**Five-Year Review Report**  
**Second Five-Year Review Report**  
**for**  
**Spickler Landfill**  
**Town of Spencer**  
**Marathon County, Wisconsin**  
**September 2005**

**Wisconsin Department of Natural Resources**  
**West Central Region**  
**Eau Claire, Wisconsin**

Fig. 3 Gas Monitoring Locations

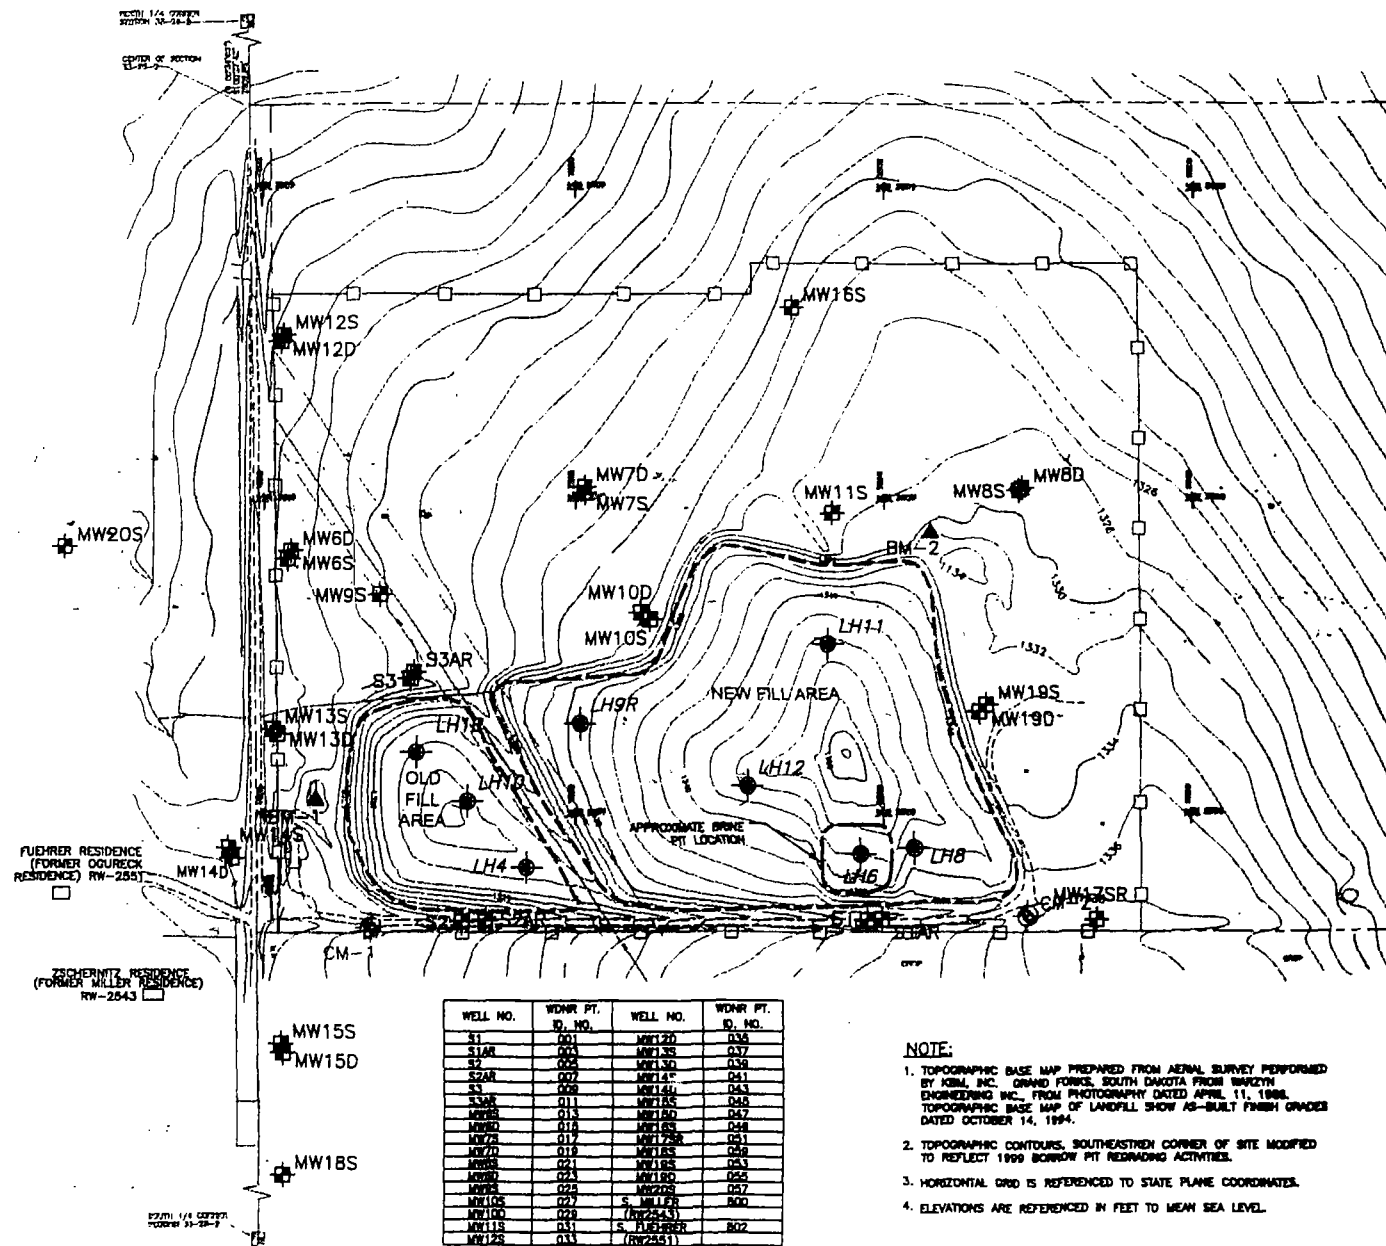
The site has 10 perimeter gas probes, and seven select water table monitoring wells are also sampled for landfill gas. Gas probe GP-6, near the west edge of the waste has had consistently high levels of methane. From 2000-2004 there were 11 gas probe samples collected at GP-6. During eight of those events the lower explosive limit (LEL) for methane was exceeded substantially. It should be noted, though, that overall, the percentage of methane in GP-6 has decreased over the life of the project. GP-5, also at the west edge of the fill area exceeded the methane LEL three times. In GP-5 there has also been a long-term decrease in the percentage of methane present.

The operation of the landfill gas extraction system has reduced the potential for off-site migration of explosive levels of methane. However, gas probe monitoring suggests that there are concentrations of methane on the site of significant concern. Gas probe monitoring also suggests that the potential exists for methane to migrate off-site.

Monitoring well MW-14S is located between the western edge of the site and one of the residences, and should be added to the gas monitoring network. All other gas probe monitoring should continue, and operation of the gas extraction system should be operated continuously.
